RE: Homestake Mining Company of California
– License SUA-1471
Grants Reclamation Project
Responses to NRC Request for Additional Information (RAI) dated 6/13/07

HOMESTAKE MINING COMPANY RESPONSES TO
Request for Additional Information, Homestake Mining Company,
Grants Reclamation Project
From the Nuclear Regulatory Commission

**SUBJECT: RESPONSE TO NRC REQUEST FOR ADDITIONAL
INFORMATION, COMMENT #2 REGARDING EMBANKMENT SLOPE
STABILITY OF EP3 EMBANKMENT**

Homestake Evaporation Pond Number 3: Response to NRC Request for Additional Information Comment No. 2

Figure 16. Pseudo-Static Analysis: Phreatic Surface 3, Corrected Janbu Method
 $g = 6.2\%$ (10% Probability of Exceedance in 50 Years, or 475 Year Return)

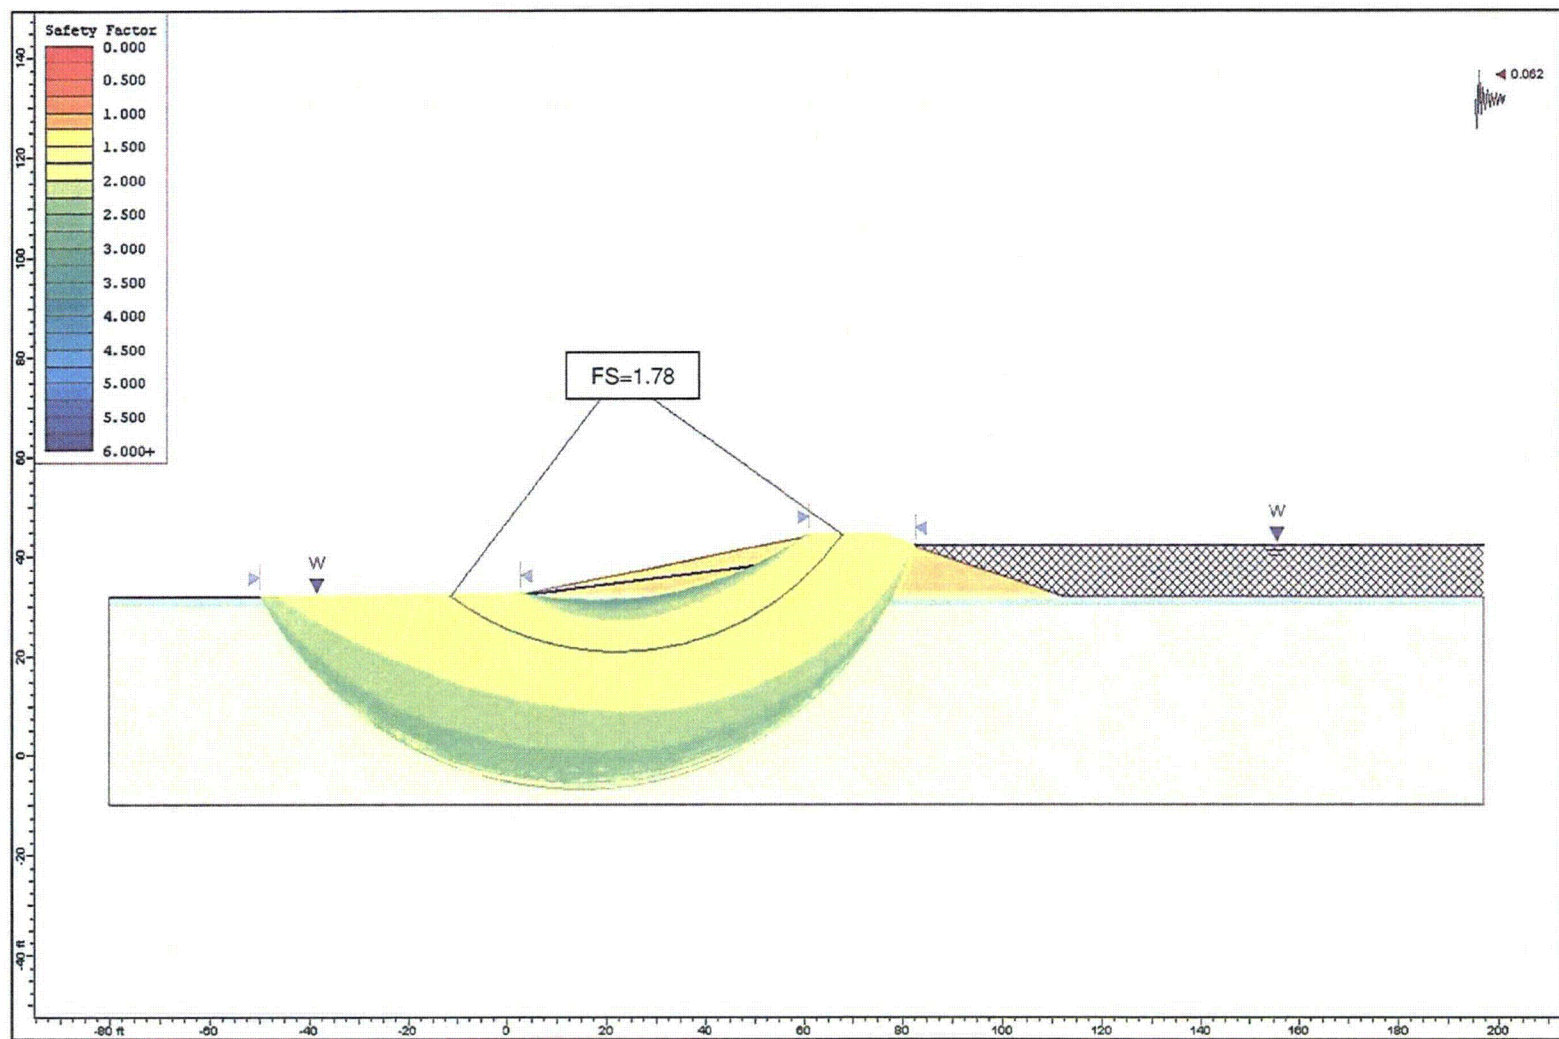
Slope stability analysis was also performed considering a seismic load applied to the EP3 embankment. This seismic load was obtained from USGS national and regional seismic hazard maps (Reference 5). A 10% probability of exceedance in 50 Years (475 Year return) peak ground acceleration value of $g = 0.062$ was used in the analysis. The three phreatic surfaces described in the previous section were added to the pseudo-static analysis, and a minimum factor of safety for each scenario was determined. Results are shown in Table 3 and Figures 11 through 18.

The minimum factor of safety of the EP3 embankment for static load conditions was 1.4 assuming completely saturated conditions (phreatic surface 1) and a complete loss of soil suction (considered to be impossible in this location). The minimum factor of safety for the pseudo-static analysis was 1.05 for fully saturated conditions where the $c \Rightarrow 0$ but the Φ would probably be between 25° and 30° . Completely saturated conditions represent the worst-case scenario for the EP3 pond. Due to the relatively high factors
